STATE OF HAWAII DEPARTMENT OF TRANSPORTATION HIGHWAYS DIVISION MECHANICALLY STABILIZED EARTH RETAINING WALL (MSERW) TYPICAL SECTION AND DETAILS KAHKILI HIGHWAY WIDENING Likelike Hwy. to Vicinity of Haiku Road F.A. PROJECT NO. NH-083-1(26) SCALE: AS NOTED DATE: APRIL 1994 SHEET No. W1 OF W21 SHEETS	
--	--

AS-BUILT ADD. 114

KAHEKILI HIGHWAY WIDENING
Likelike Hwy. to Vicinity of Haiku Road
F.A. PROJECT NO. NH-083-1(26)

**PLAN AND PROFILE
 MSERW AND R.C. WALLS**

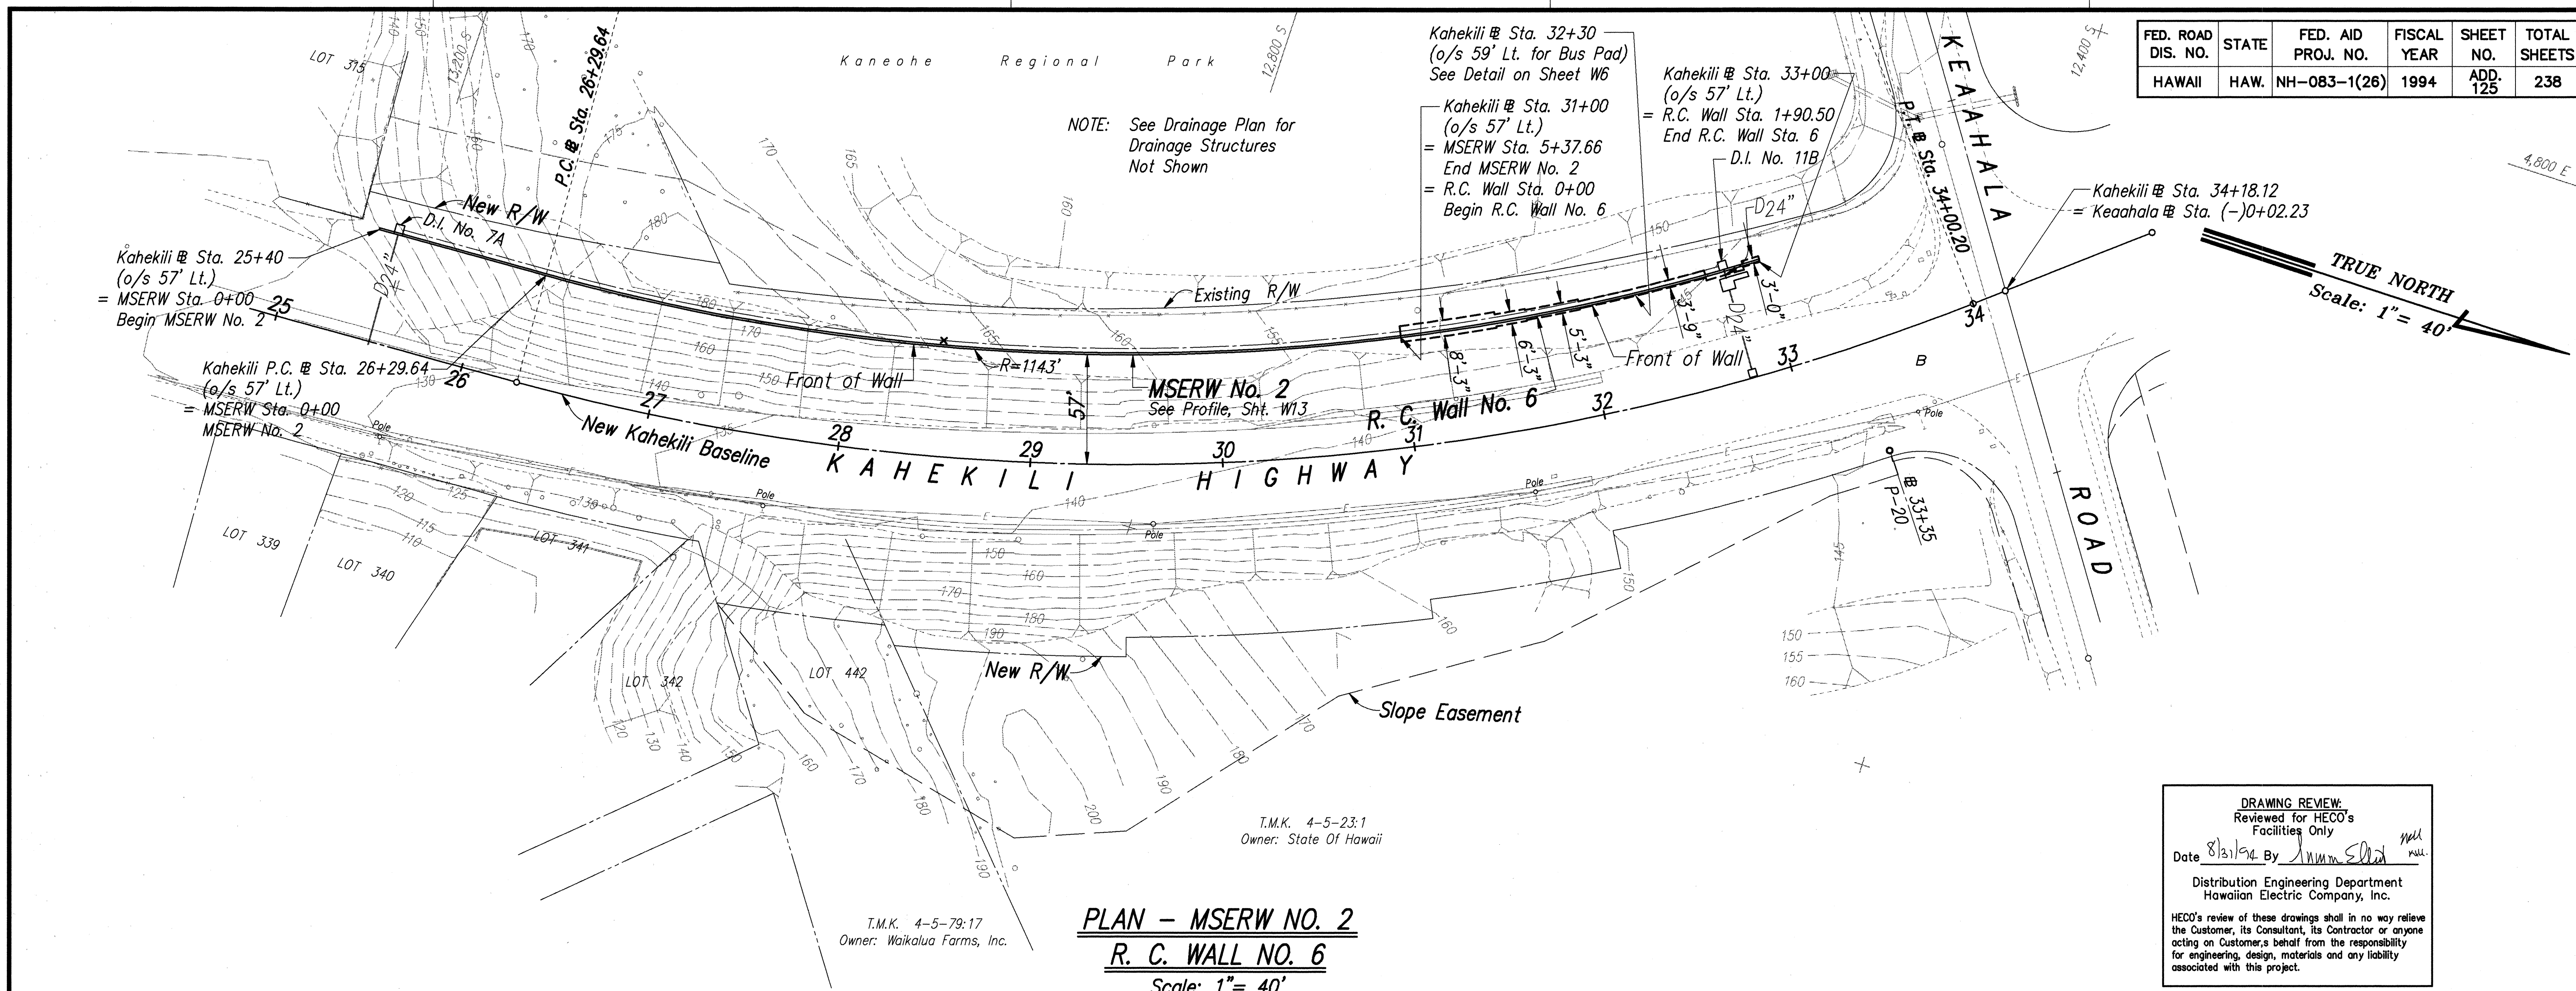
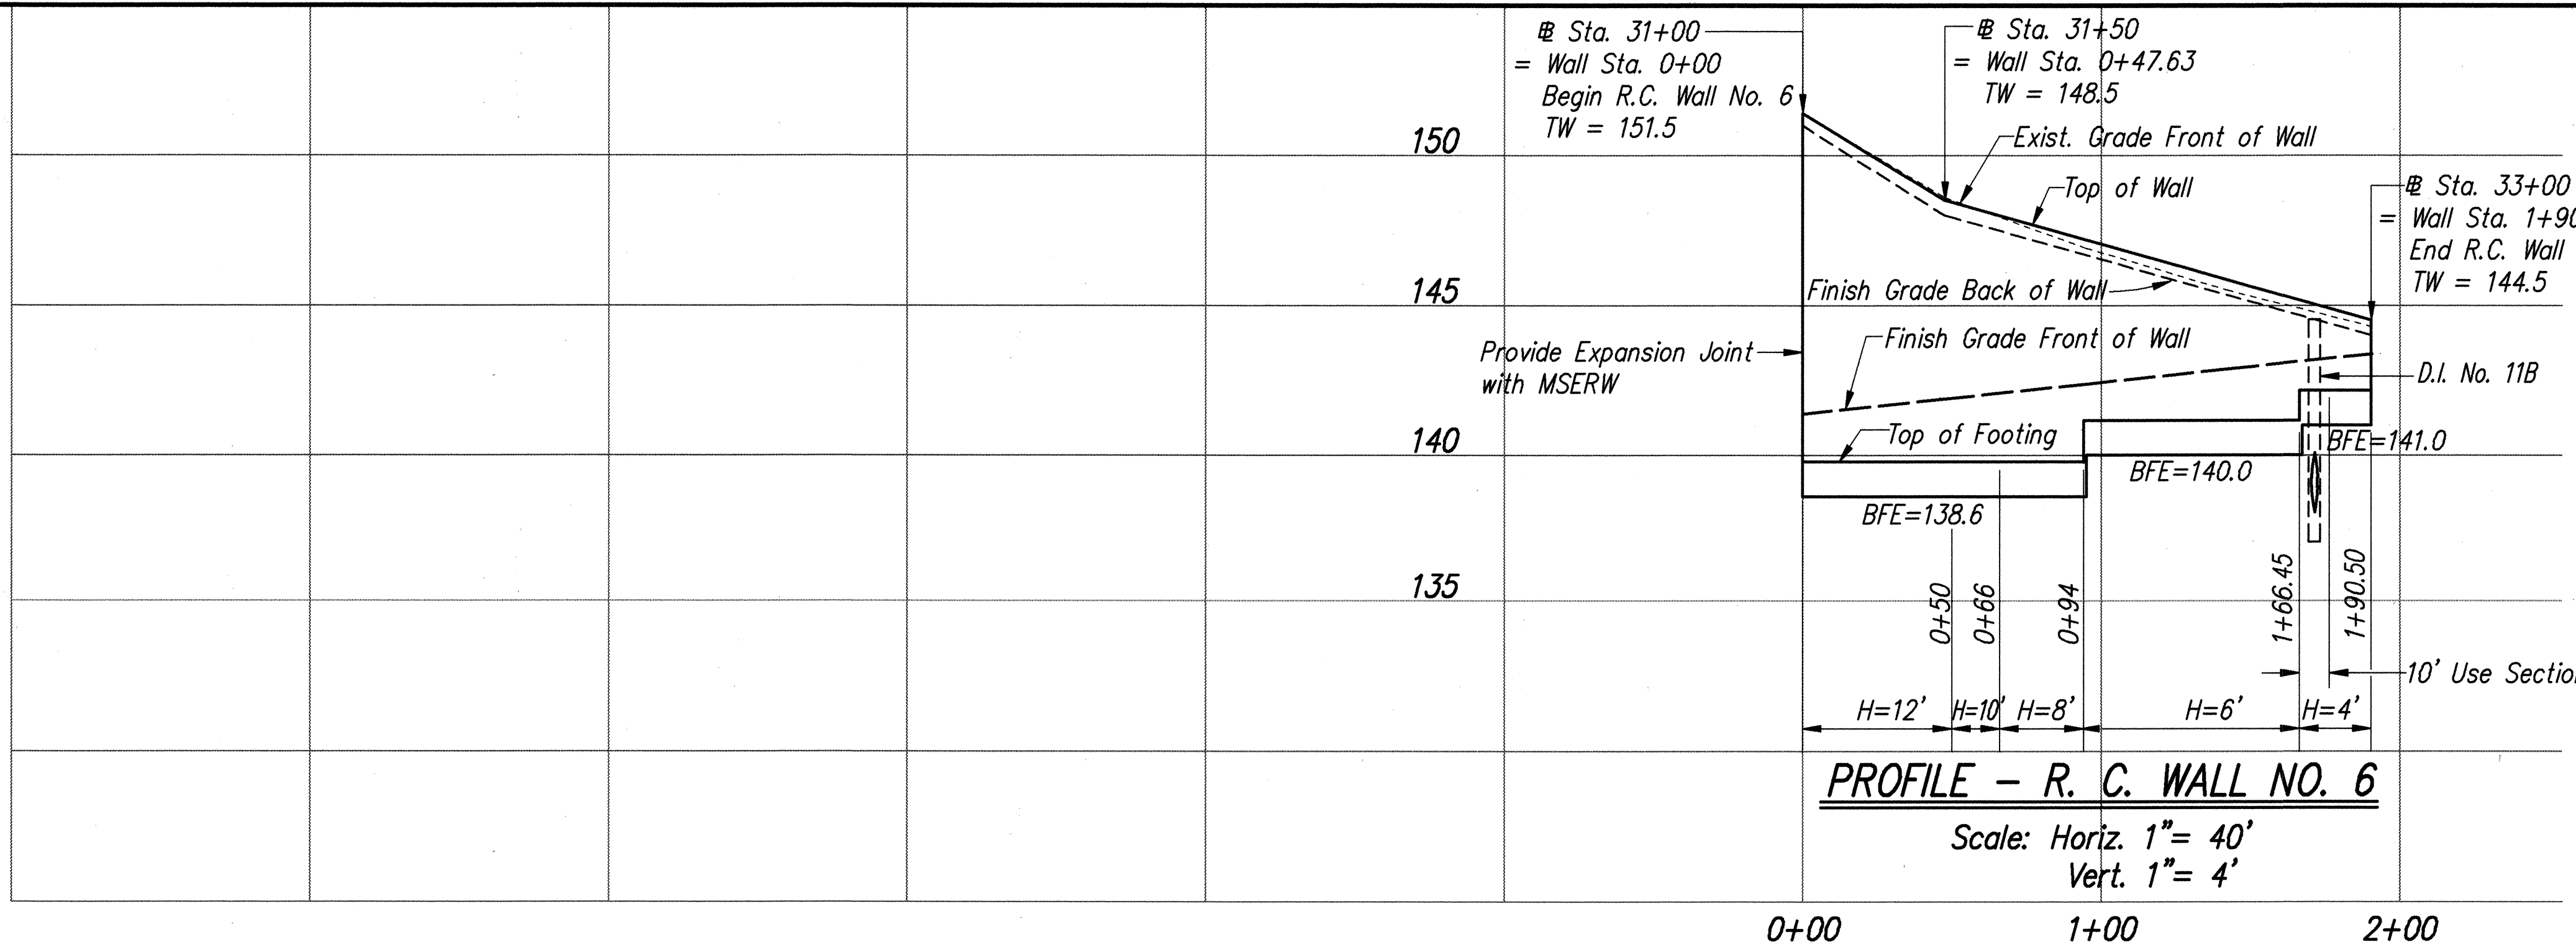
11/06/95	DELETED MSERW NO. 3 AND NO. 4 AND R.C. WALL NO. 5; REVISED SLOPE EASEMENT
6/07/94	ADDED POLE P-20 AND HECO SIGNATURE BLOCK.
DATE	REVISION

PLAN AND PROFILE
R. C. WALL NO. 7, 8, 9 AND 10

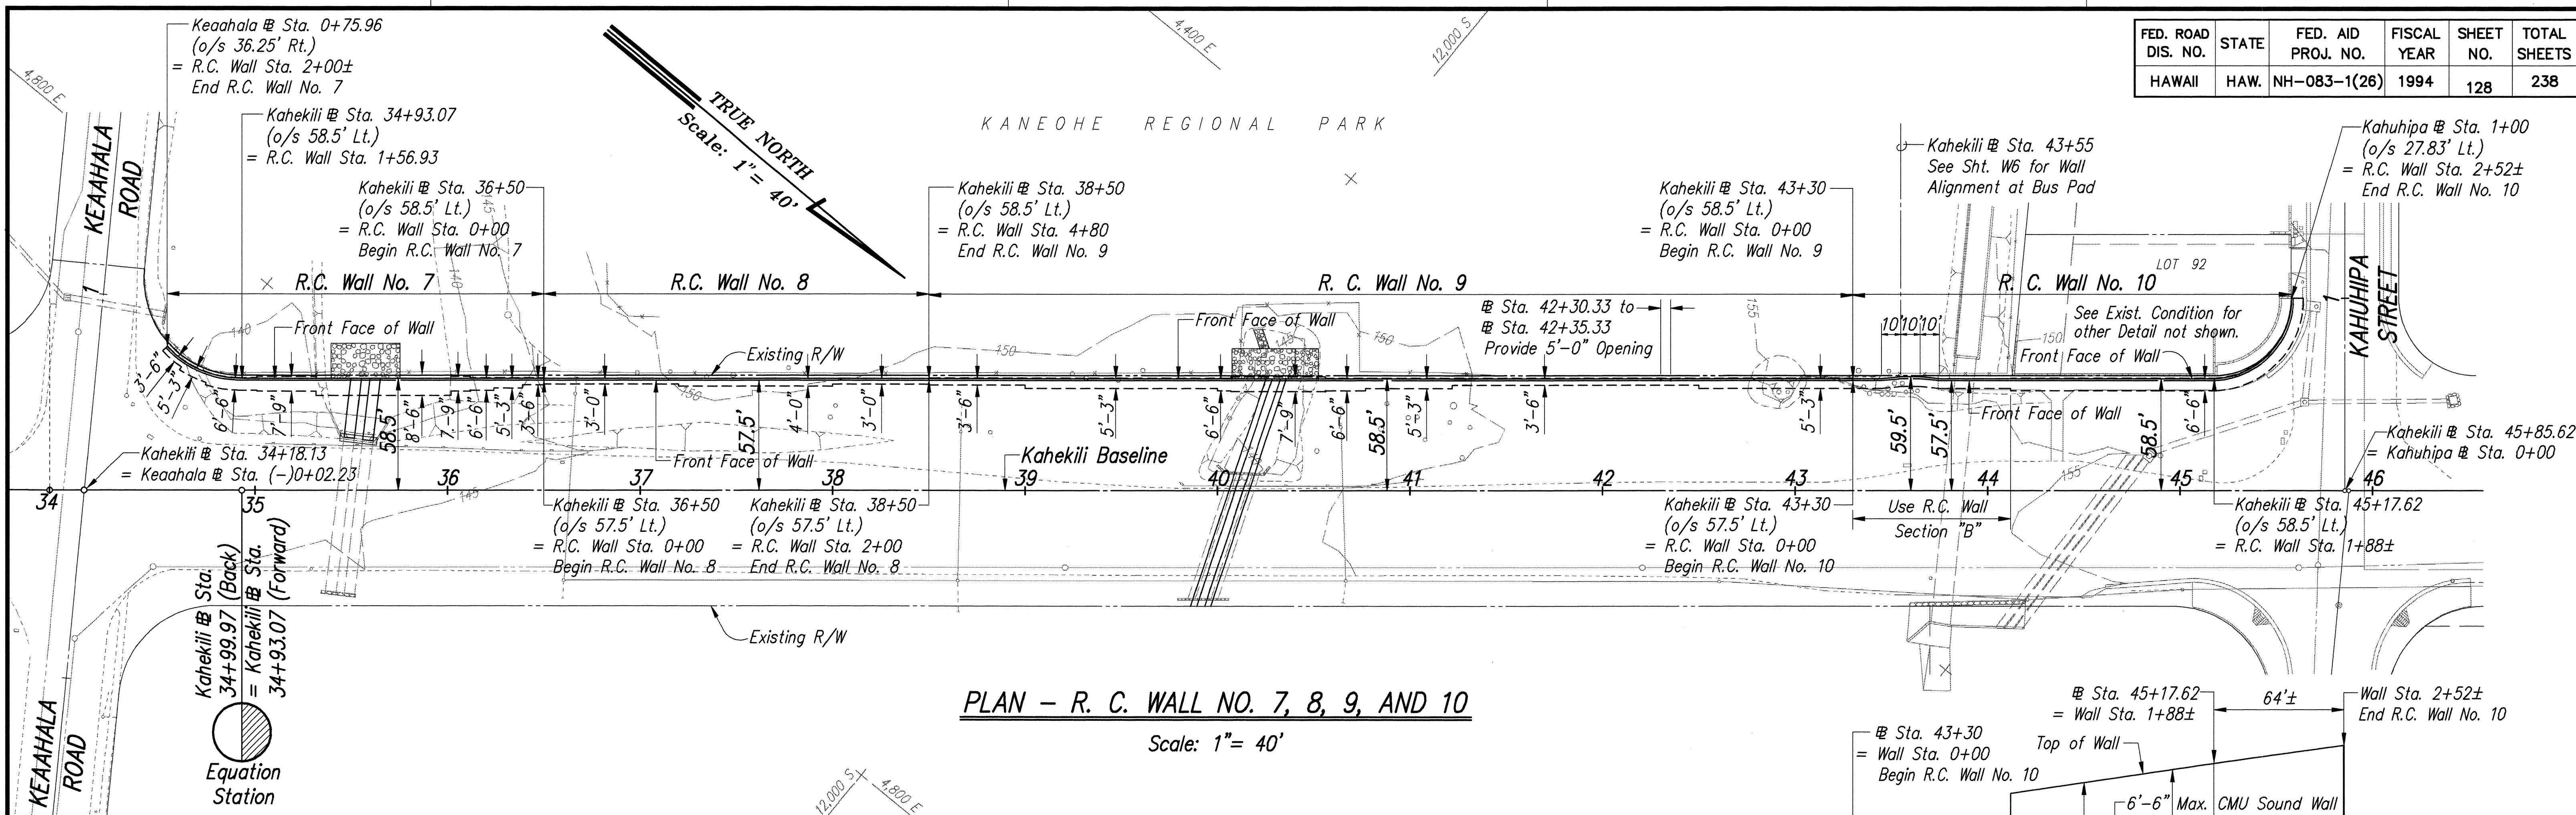
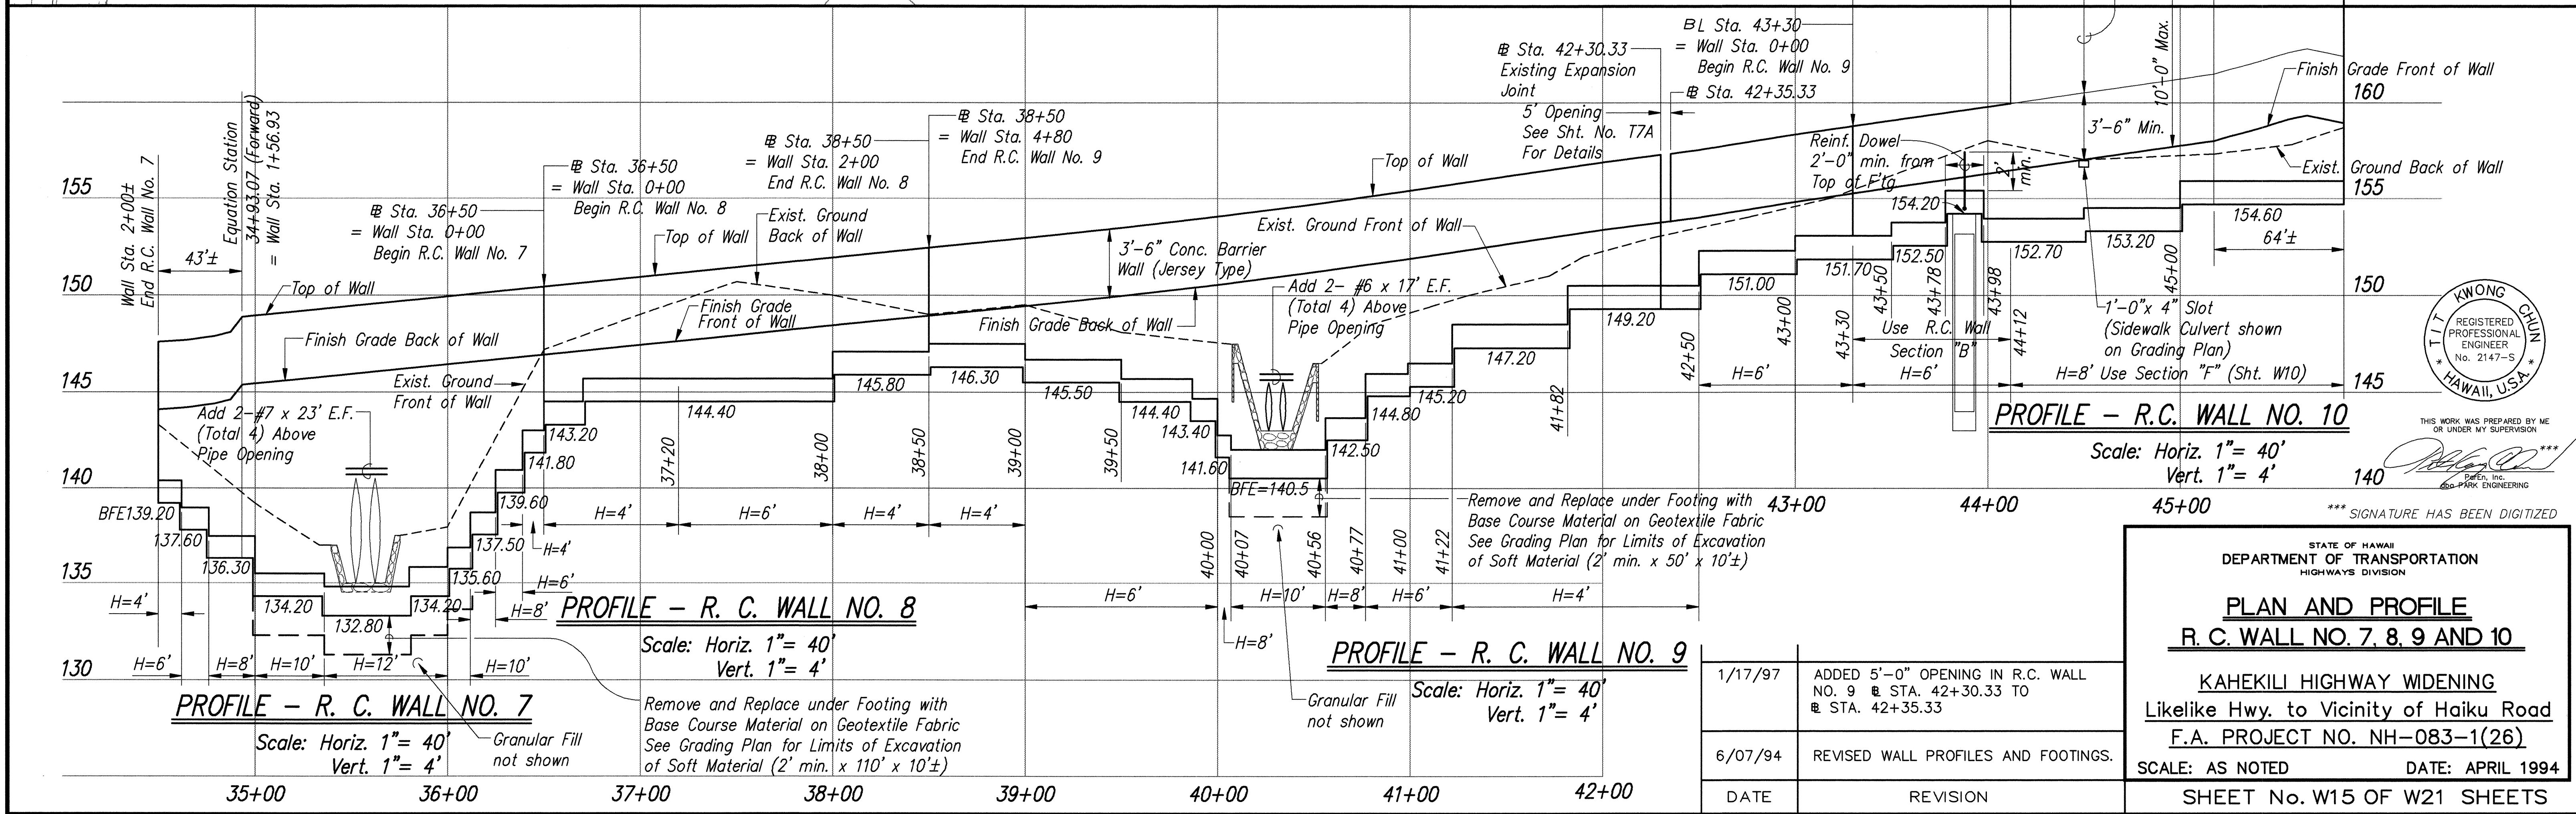
DATE	1/17/97
DESIGNED BY	ADD 5'-0" OPENING IN R.C. WALL NO. 9 @ STA. 42+30.33 TO STA. 42+35.33
DESIGNED BY	REVISED WALL PROFILES AND FOOTINGS.
CHECKED BY
